From: Distel, David J:(GenCo-Nuc) <David.Distel@exeloncorp.com>
Sent: Wednesday, February 15, 2017 8:47 AM
To: Hughey, John
Cc: Mokkapati, Sailaja:(GenCo-Nuc); Seo, Timothy P:(GenCo-Nuc)
Subject: [External_Sender] Response to Additional NRC Questions on Braidwood SFP Instrumentation
Attachments: Braidwood SFPI SE RAIs.docx

BRAIDWOOD FOLLOW-UP SFPI RAI QUESTIONS

The NRC staff has reviewed Exelon's June 9, 2015, Spent Fuel Pool Instrumentation (SFPI) Order compliance report (ADAMS Accession No. ML15160A351) for Braidwood and has determined that additional information is needed in order for the NRC staff to complete its review. Please provide a response by email to the following questions. Request for Information (RAI) numbers 7 and 13 are follow-up questions to those questions in the Interim Staff Evaluation (ISE), ADAMS Accession No. ML13280A566. RAI numbers 15 and 16 are follow-up questions to questions asked during the onsite audit. The NRC's safety evaluation tracker file for Braidwood may contain amplifying information.

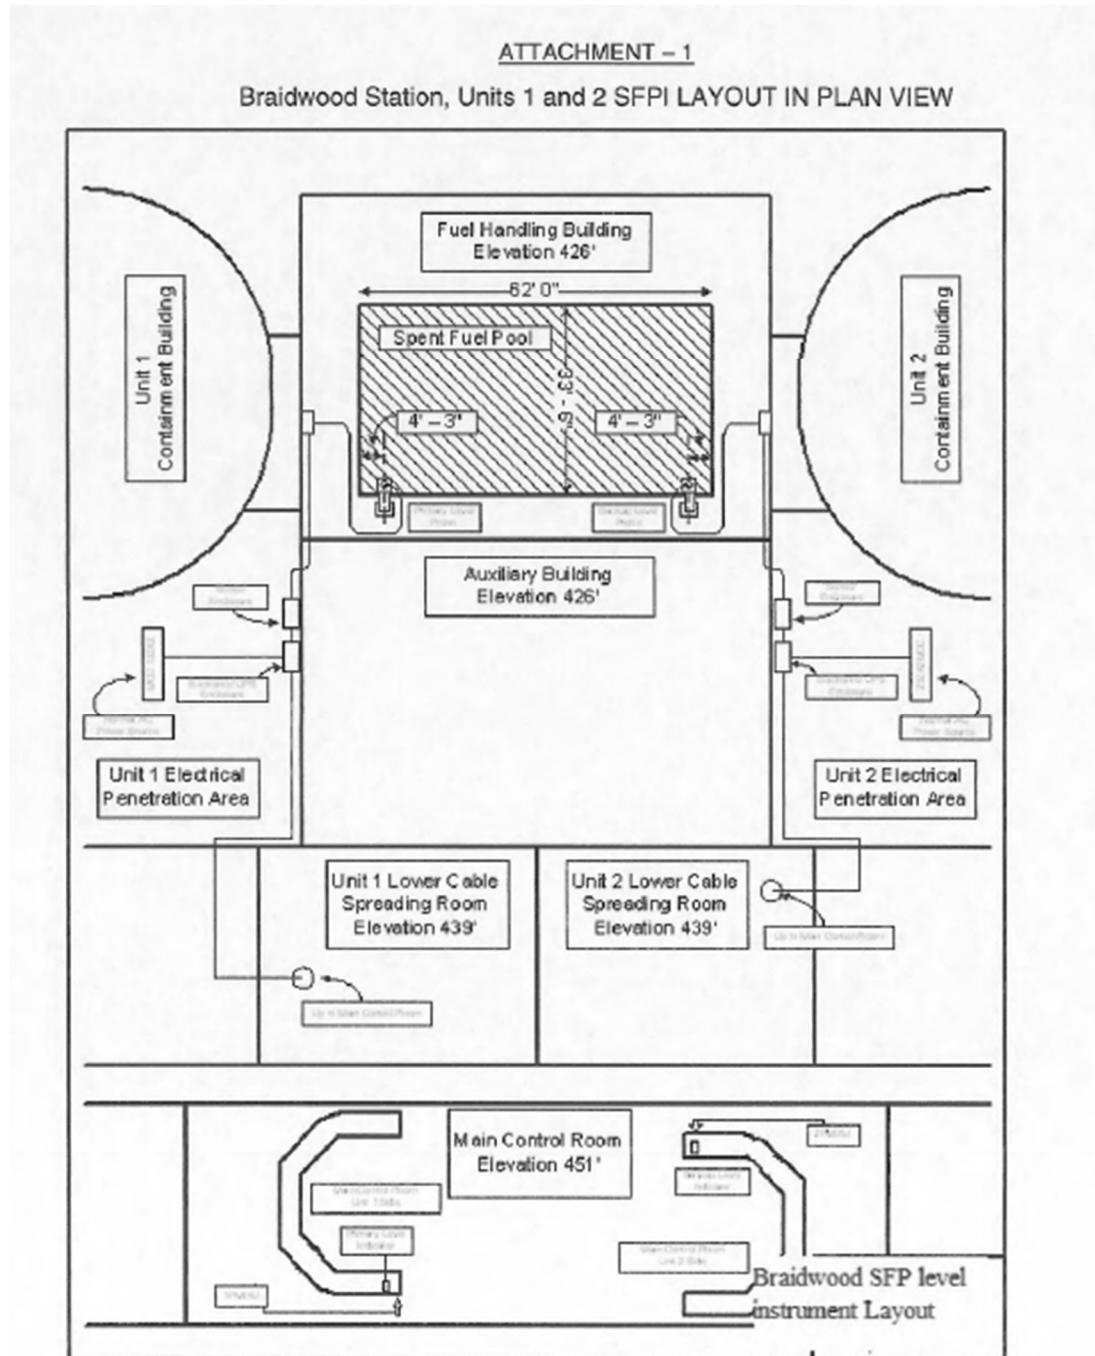
It is not clear whether the listed BDB temperature has analyzed for the maximum temperature during an ELAP event. It is also not clear whether the BDB radiological condition analyzed for the radiation total integrated dose (TID) 12 inches above the fuel rack, which could be 1E09 R y at the SFP area.

- a. Maximum temperature of the Electrical Penetration Area including temperature during an ELAP event, when HVAC is not available and how the SFP level instrument equipment installed in that area maintains its design function under that condition.
- b. Radiological condition of the Electrical Penetration Area when the SFP water level reach Level 3 and how the SFP level instrument equipment installed in that area maintains its design function under that condition.

a. Spent Fuel Pool Level instrument components are located in EQ Zone A11. Per calculation BRW-01-0153-E, Revision 2 (Environmental Parameters of EQ Zones), EQ Zone A11 is a Mild Zone with maximum normal temperature of 133 Degrees F. EQ Zone A11 does not have a temperature for accident conditions, however, Note 14 of the calculation addresses conditions of LOCA and LOOP as follows": Under conditions of LOCA and LOOP, maximum temperature will increase during 2-hour period due to HVAC systems operation using available electrical power sources and with consideration of equipment heat loads for event mitigation. Maximum temperatures during this condition are: 140 Degrees F for Zone A11." The bounding value of 140 Degrees F is determined in calculation VA-102, Revision 4 (Aux Bldg. Energy Load Calcs for EI. 330' 346', 364', 383' 401' & 426' in Abnormal Condition), which determines temperatures for multiple locations within EQ Zone A11, as follows:

Unit 1 and Unit 2 Electrical Penetration Area (EI 426')	Calculated Temperature = <u>127.1 F</u>
Unit 1 and Unit 2 Electrical Penetration Area (EI 414')	Calculated Temperature = <u>125.3 F</u>
Unit 1 and Unit 2 Electrical Equipment Room (EI 414')	Calculated Temperature = <u>138.2 F</u>
Unit 1 and Unit 2 Motor Driven AF Pump Rooms	Calculated Temperature = <u>135.8 F</u>
Unit 1 and Unit 2 Diesel Driven AF Pump Rooms	Calculated Temperature = <u>133.0 F</u>

With the Primary and Secondary SFP Level electronics located in Unit 1 and Unit 2 Electrical Penetration Areas, El 426', the calculated temperature of this location is 127.1 F during conditions of LOCA and LOOP for a 2-hour period, which is below the stated 140 F maximum temperature for Zone A11 (140 F bounds all locations above in EQ Zone A11).

The LOCA and LOOP conditions described above include heat loads from electrical equipment and liquid systems that will not exist during an Extended Loss of Power Event (ELAP). During an ELAP event, there will be no heat loads from electrical equipment or liquid systems in the area. The heat generated from the Spent Fuel Pool has to conduct to 426' Electrical Penetration Areas, which includes a 3' concrete wall. There is a significant heat sink in the 426' Electrical Penetration areas from the containment wall and surrounding Auxiliary Building walls. There is also a significant heat sink from the Fuel Handling Building walls and ceiling. Due to the lack of heat sources in the area of the instruments, barriers between the Fuel Handling Building and instrument areas, and the large heat sink that will dissipate heat, the 140 F rating of the SFP Level instrumentation is adequate.
